Title & Document Type: 3400A RMS Voltmeter Operating and Service Manual

Manual Part Number: 03400-90013

MANUAL CHANGES

-hp- MODEL 3400A

Figure CS-1. Figure 6-1 Changes (Change #4)

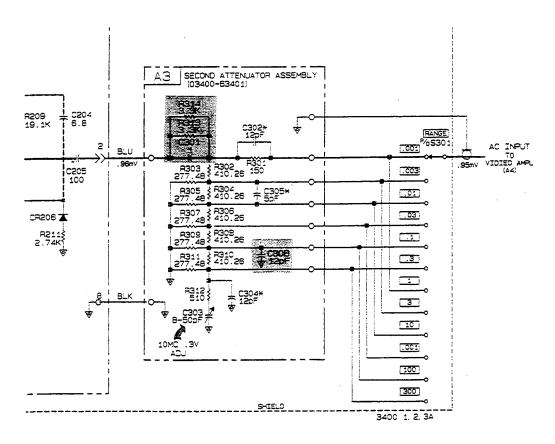
Section VI, Figure 6-1 (A1, A2, and A3 Schematic). Do the schematic changes in Figure 6-1 as shown in Figure CS-1 (in shaded area).

Figure 6-1. Input Attenuator A1, Impedance Converter A2, and Second Attenuator A3 Schematic and Parts Location Diagram 6-3/6-4

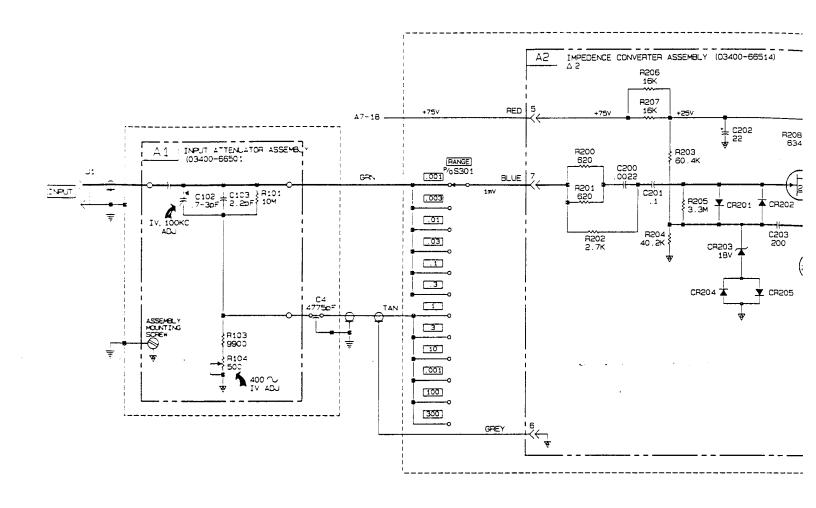
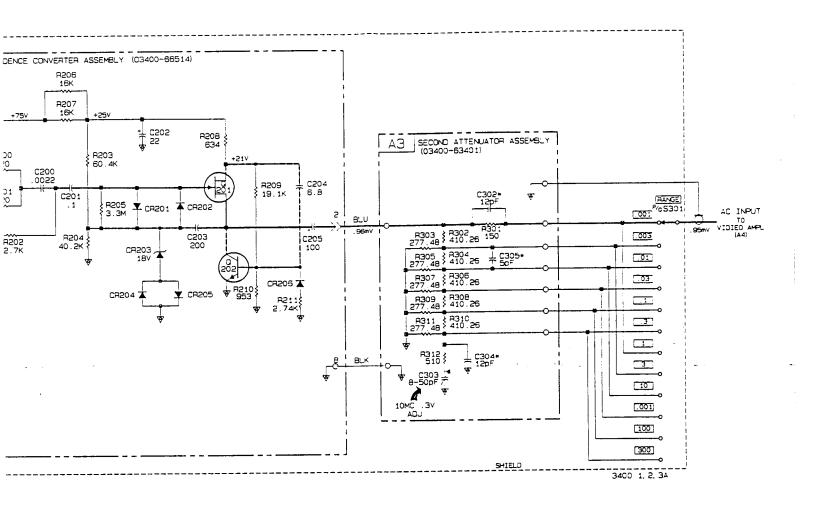
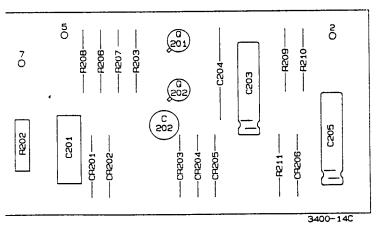
Section VI, Figure 6-1 (A1, A2, and A3 Schematic). Change the word "VIDIEO" to "VIDEO" at the AC INPUT point.

Figure 7-2 3400A Top View

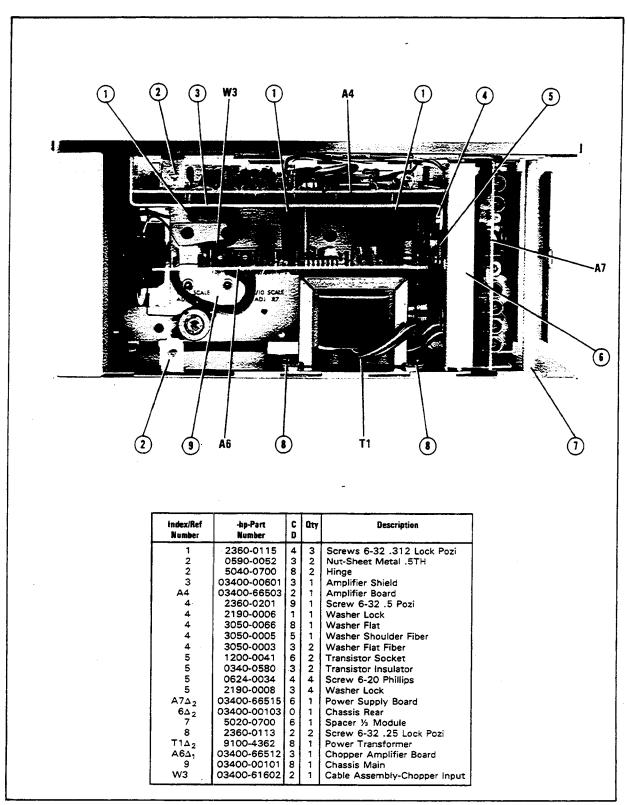
Section VII, Figure 7-2 Changes. Do the following changes in the table located in Figure 7-2.

Index/Ref Number	-hp- Part Number	CD	Description
A7 6 T1	03400-00102	9	Change Part Number of Power Supply Change Part Number of Rear Chassis Change Part Number of Transformer

Figure 7-4 3400A Bottom View with Shield Removed

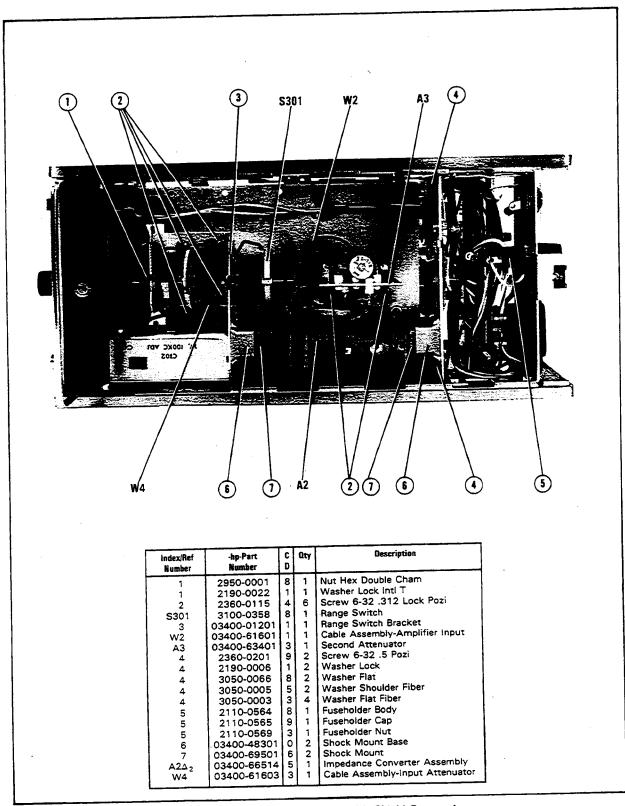
Section VII, Figure 7-4 Changes. Change the part number of the A2 Assembly from "03400-66514" to "03400-66502".

Figure 7-5 3400A Rear View

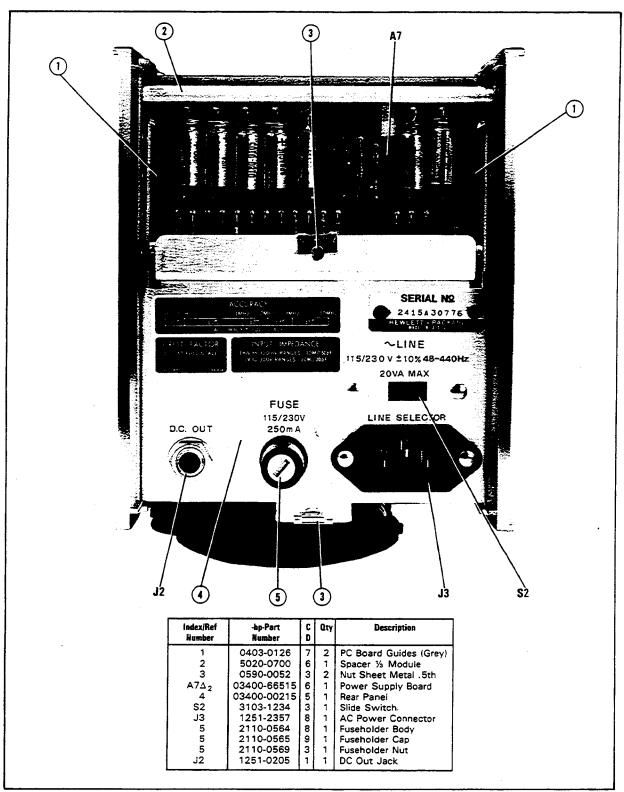
Section VII, Figure 7-5 (3400A Rear View). Change the -hp- Part Number of S2 in the table located in Figure 7-5 from "3103-1234" to "3101-1234".

Section VII, Figure 7-5 Changes. Change the part number of the A7 Assembly from 03400-66515 to 03400-66513.

Figure A-2. Figure 6-3 Schematic (Change #1)
A-5/A-6

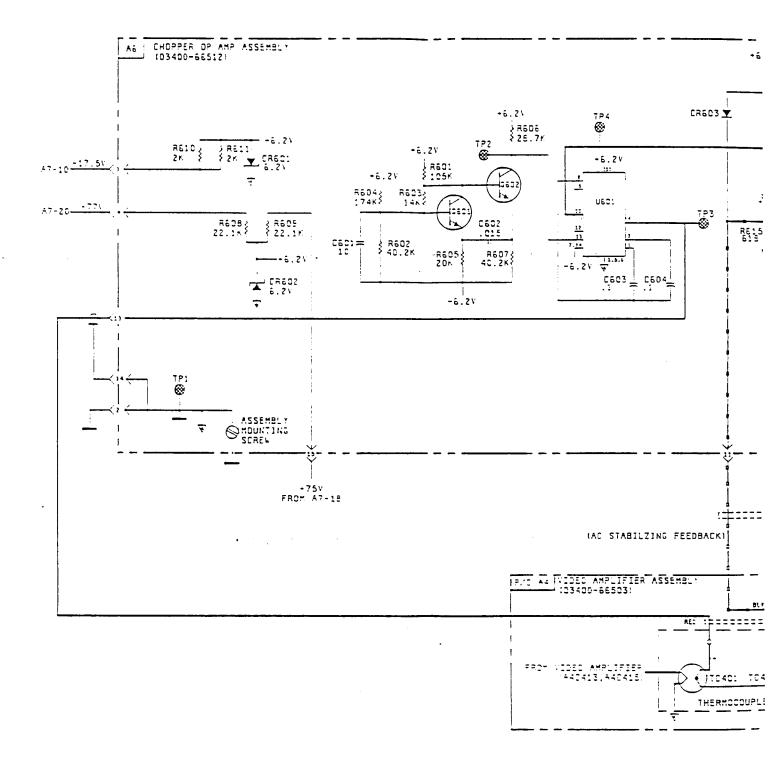
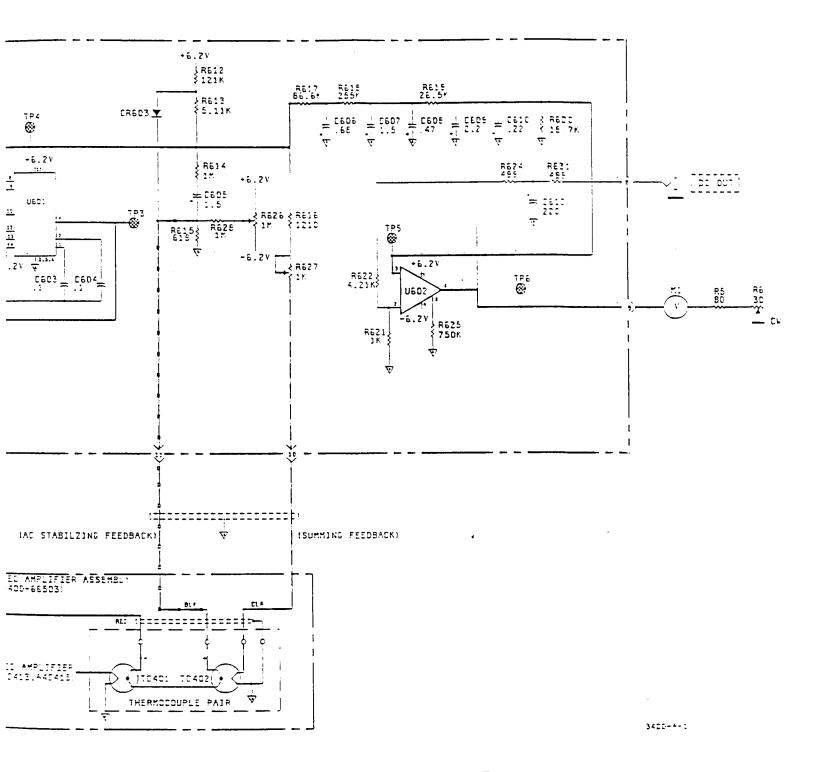
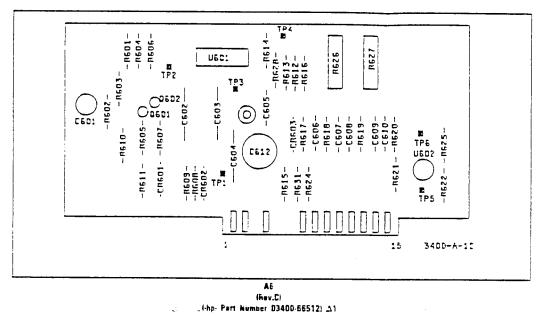
Section VI, Figure 6-3 Changes. Use component locator in Figure A-1 and the schematic in Figure A-2. The shaded area on the schematic pertains to the changes.

Reference Designator	hp- Part Number	C	Description
R621	0757-0280	0	Change to 1 K 1% .125W Resistor
R622	0698-3454		Change to 4.22 K 1% .125W Resistor
R625	0683-7545		Change to 750 K 5% .25W Resistor
R629	2100-3355		Delete 100K Potentimoter

Figure A-3. Figure 6-1 Changes (Change #2) A-7/A-8

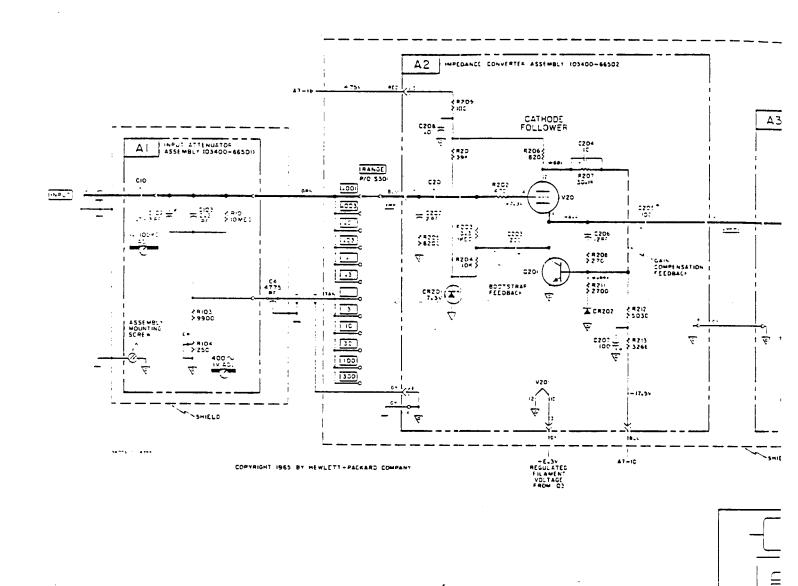
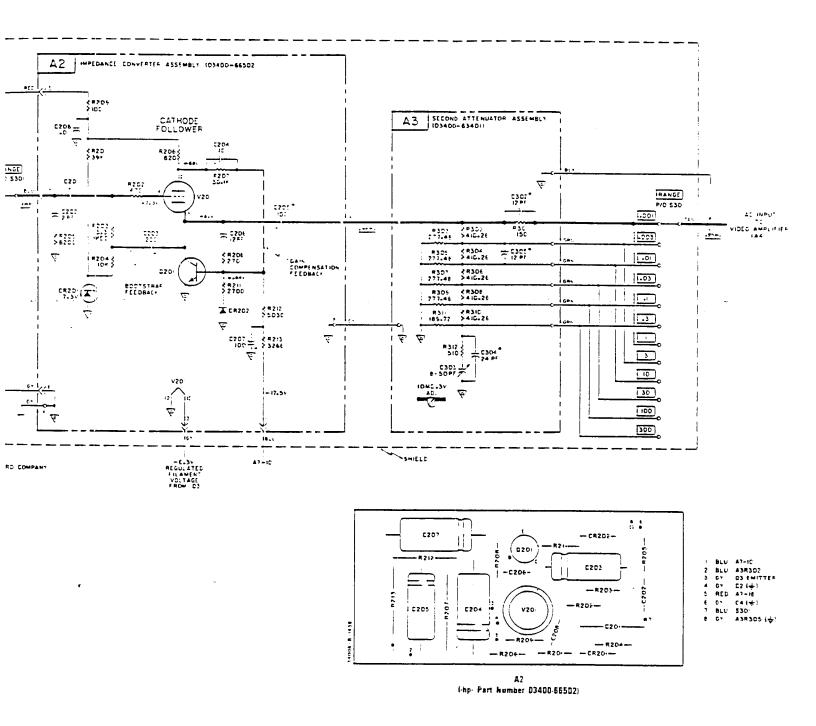
Section VI, Figure 6-1 Changes. Use component locator and schematic in Figure A-3.

Figure A-5. Figure 6-4 Schematic Changes (Change #2) A-9/A-10

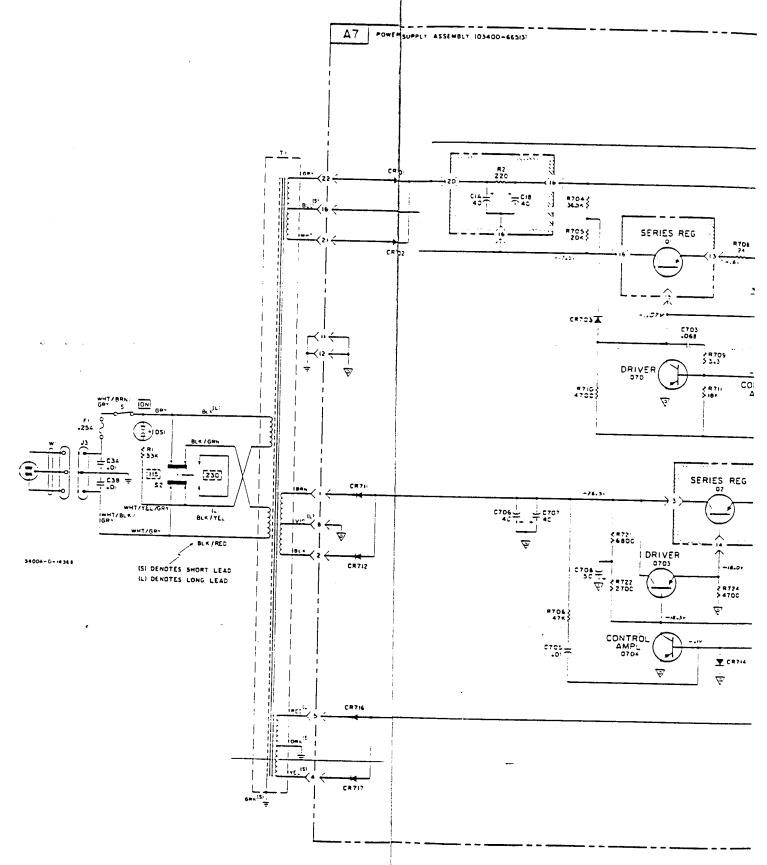
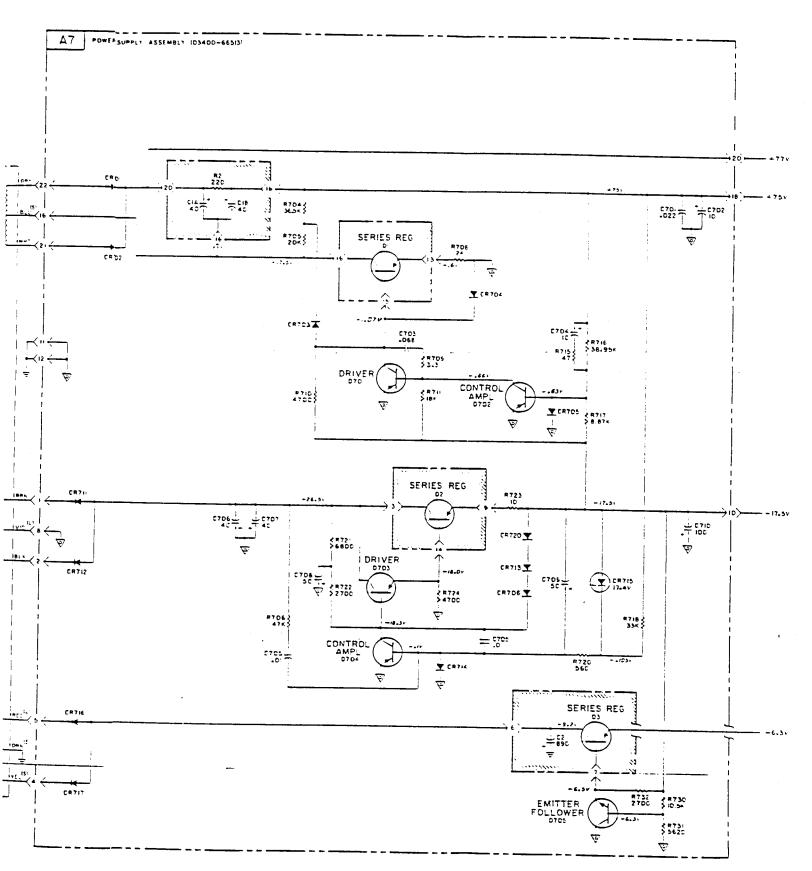
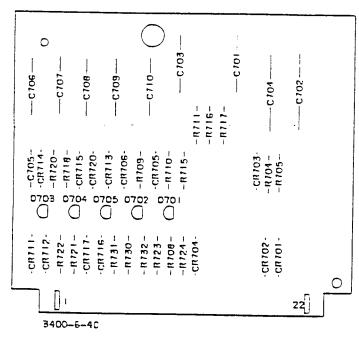
Section VI, Figure 6-4 Changes. Use component locator in Figure A-4 and schematic in Figure A-5. The shaded area on the schematic pertains to the changes.
